# CONSTRUCTION PLANS FOR THE HILLS AT LORSON RANCH FILING NO. 3

## STREET & STORM SEWER CONSTRUCTION PLANS

**THE RIDGE AT LORSON RANCH FIL NO. 3  
STREET & STORM SEWER  
CONSTRUCTION PLANS**

DATE: NOV, 2021  
PROJECT NO. 100.068  
SHEET NUMBER **C0.1**  
TOTAL SHEETS: 18

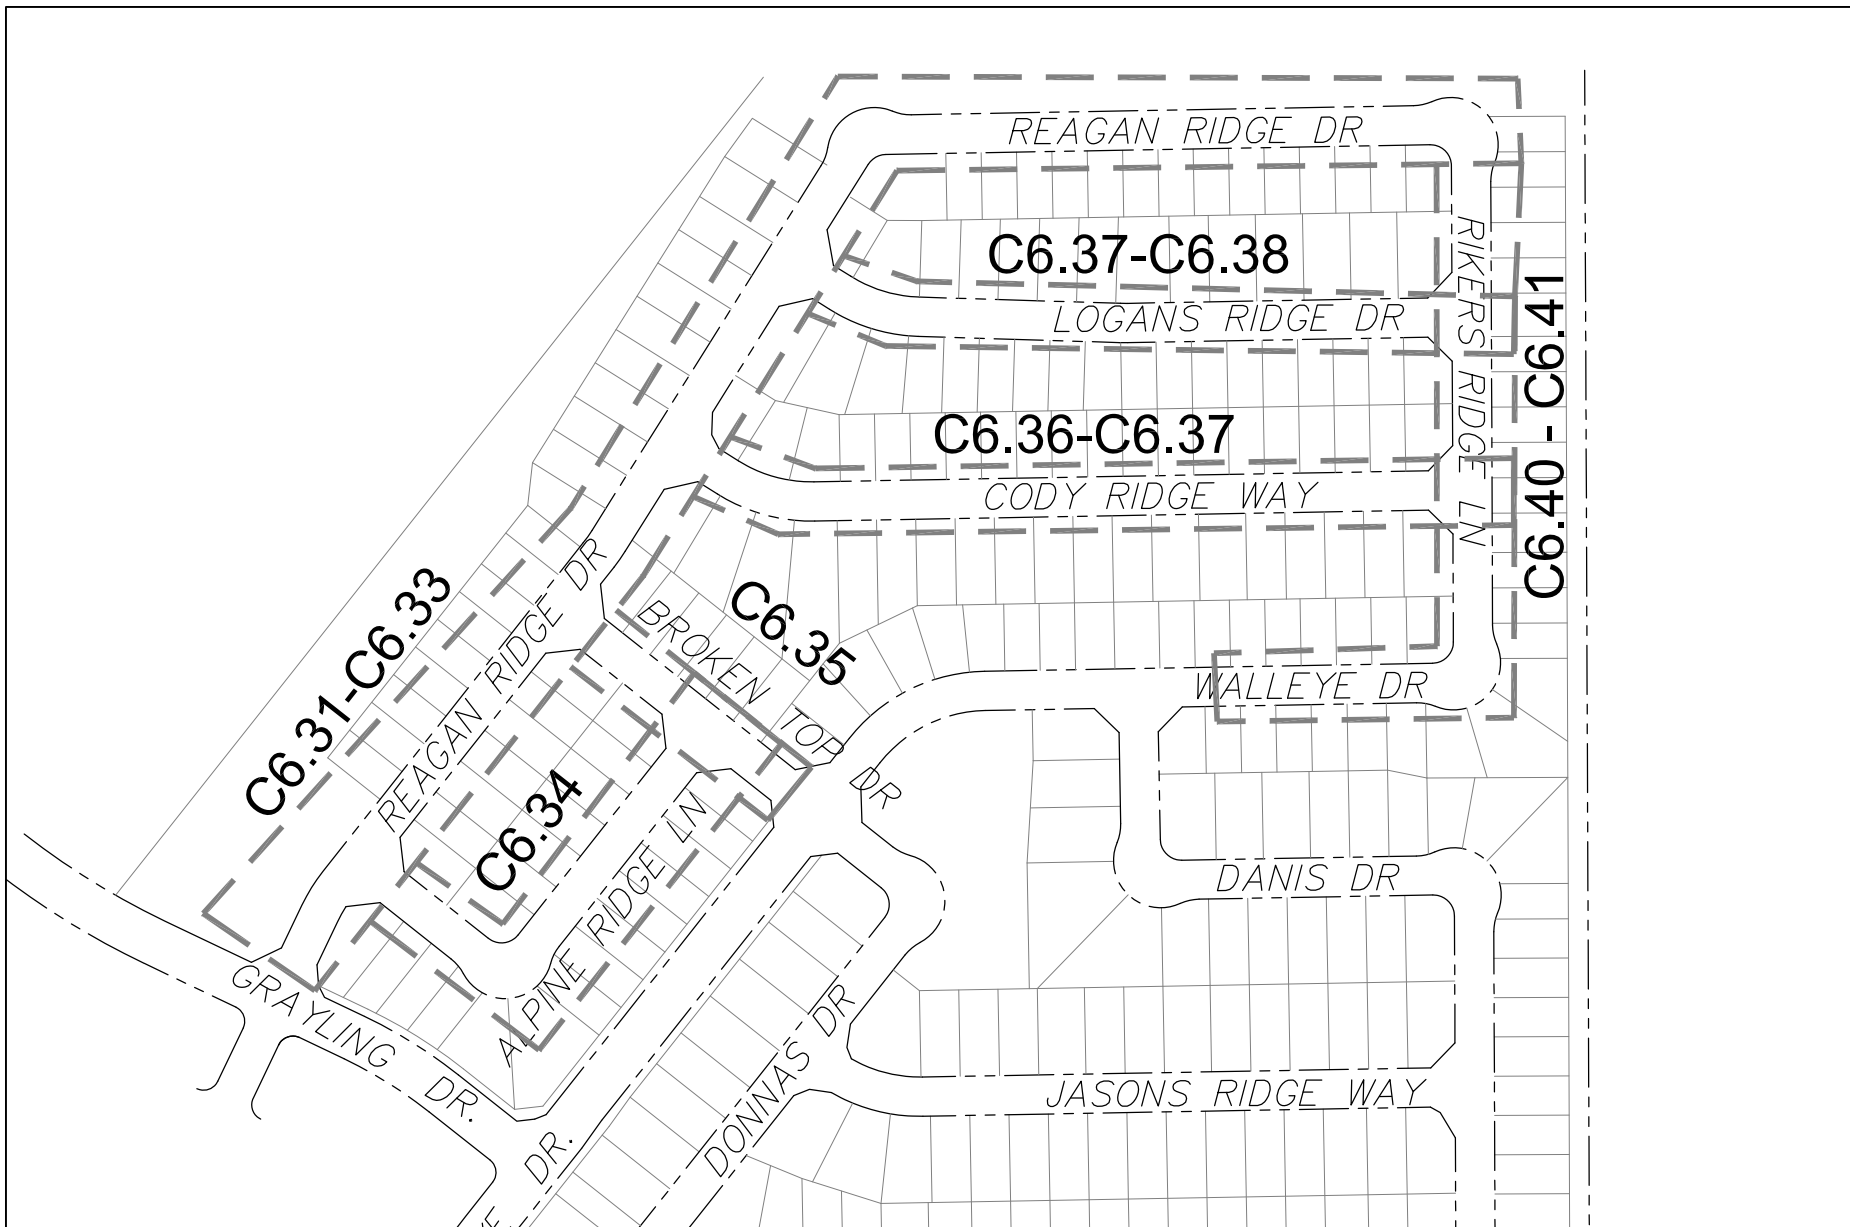
Does not match sheet #

**SIGNING AND STRIPING PLAN**

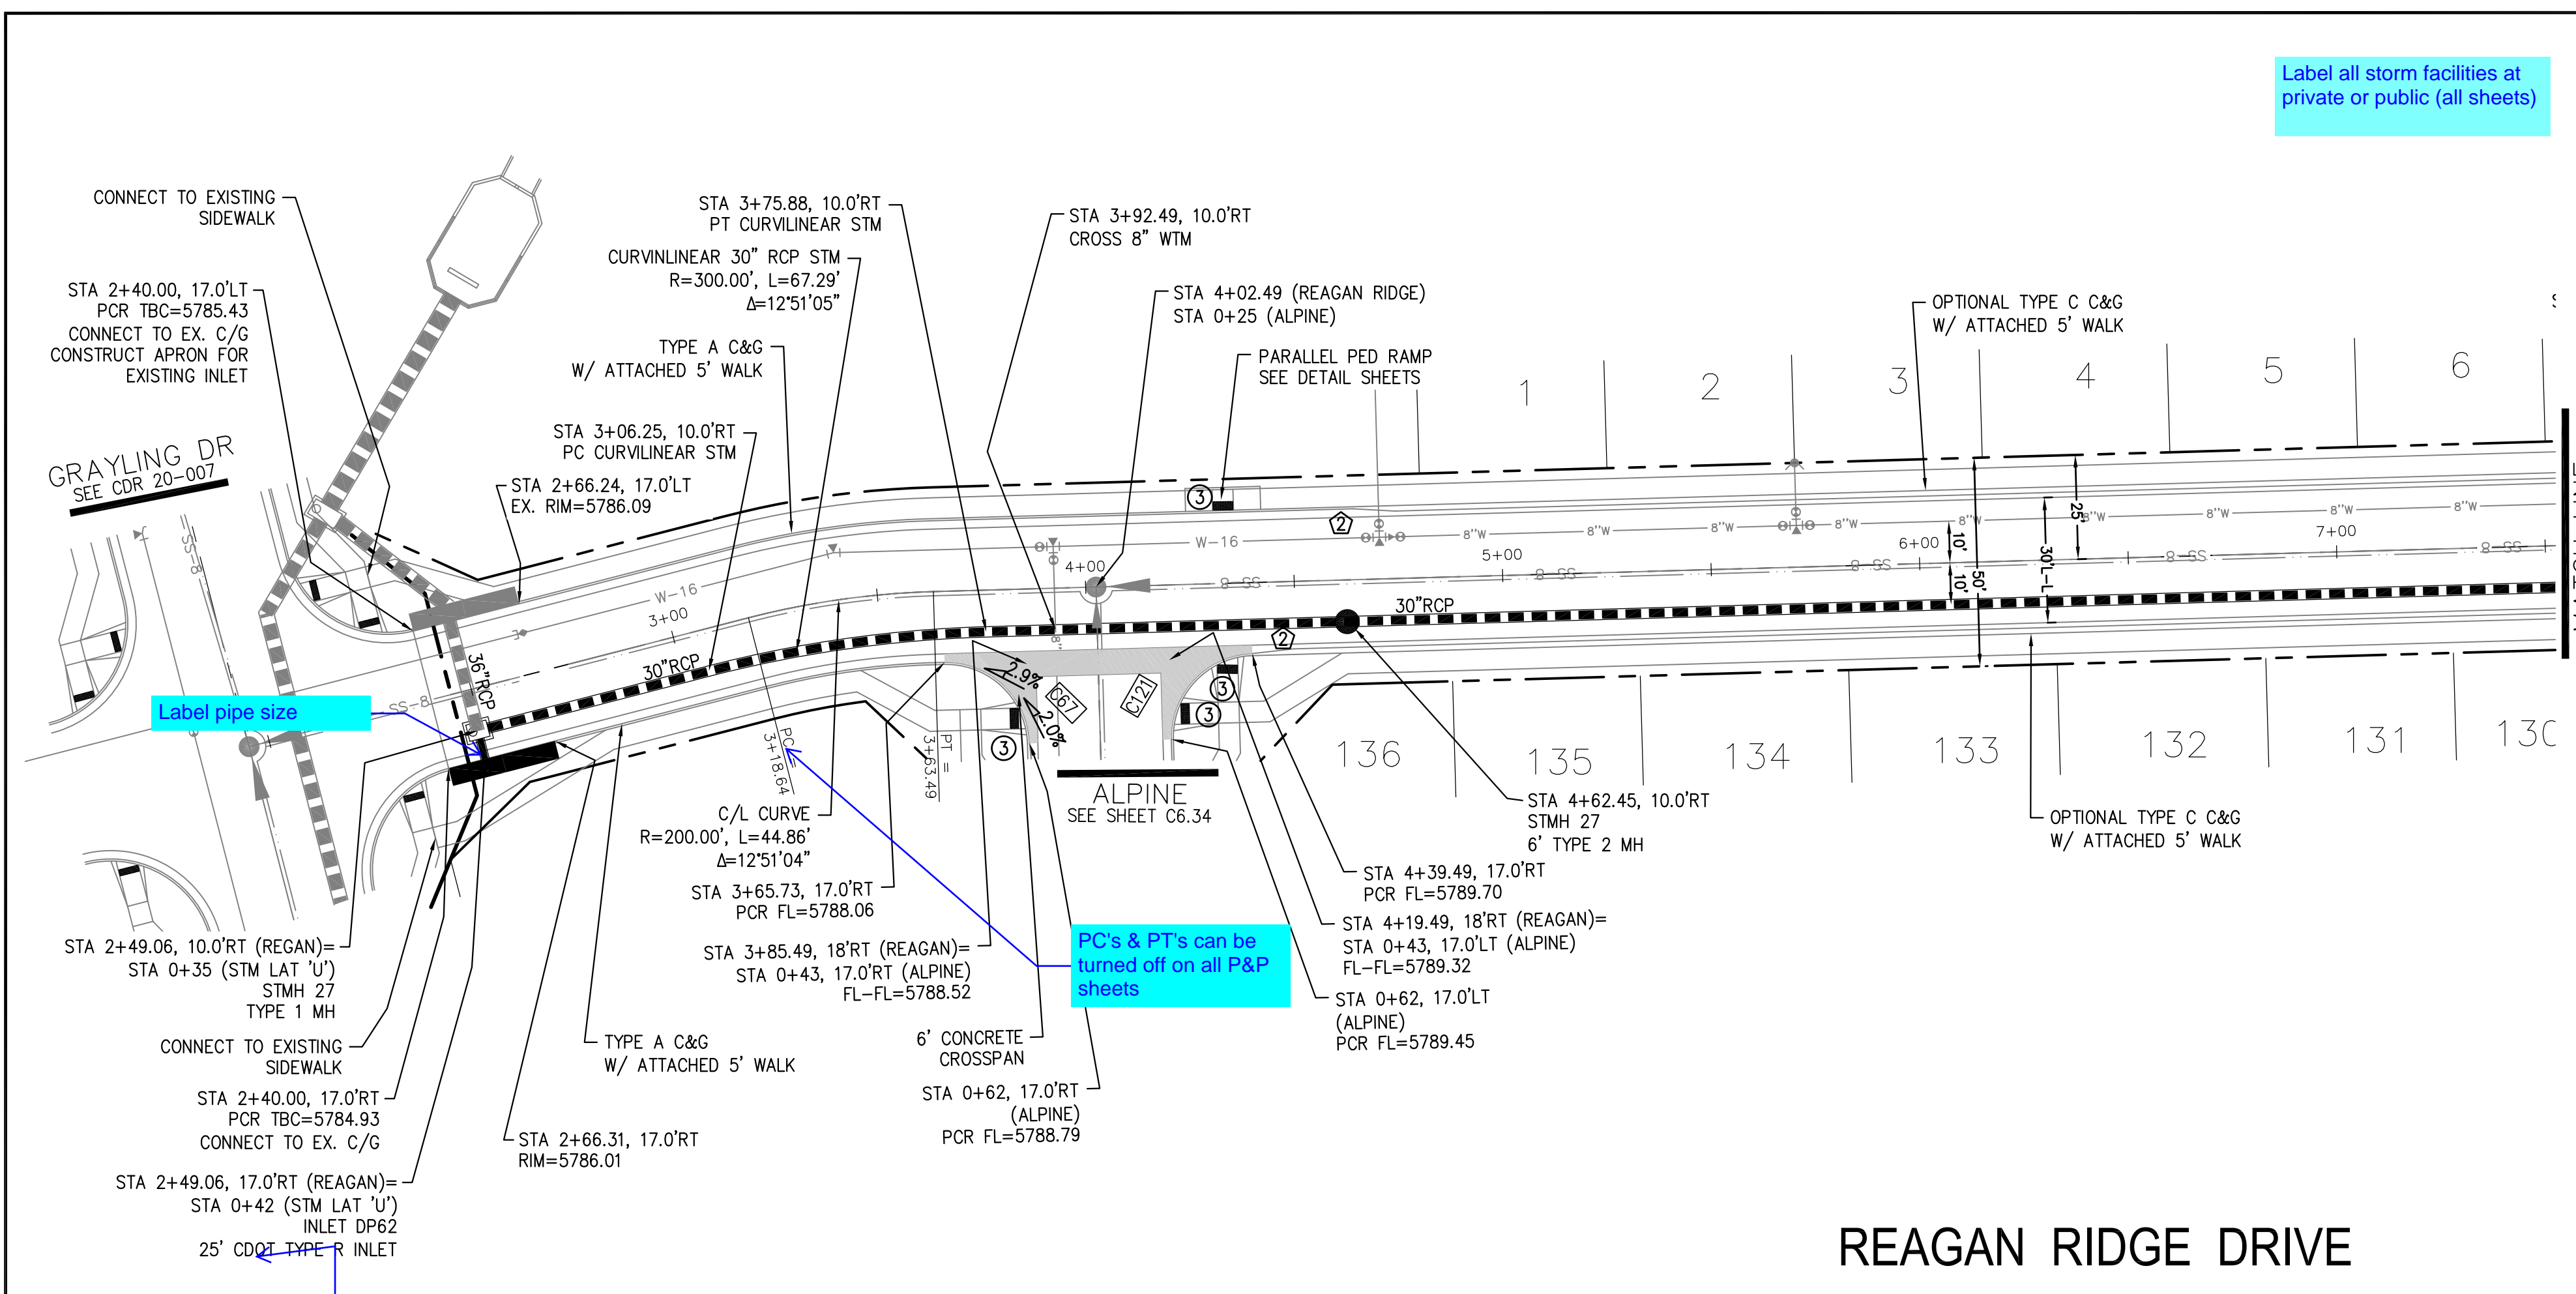
include sizes for all signs.

Provide details for pavement markings or reference CDOT standard striping detail sheet (S-627-1)

Show & label mail kiosk location/easement
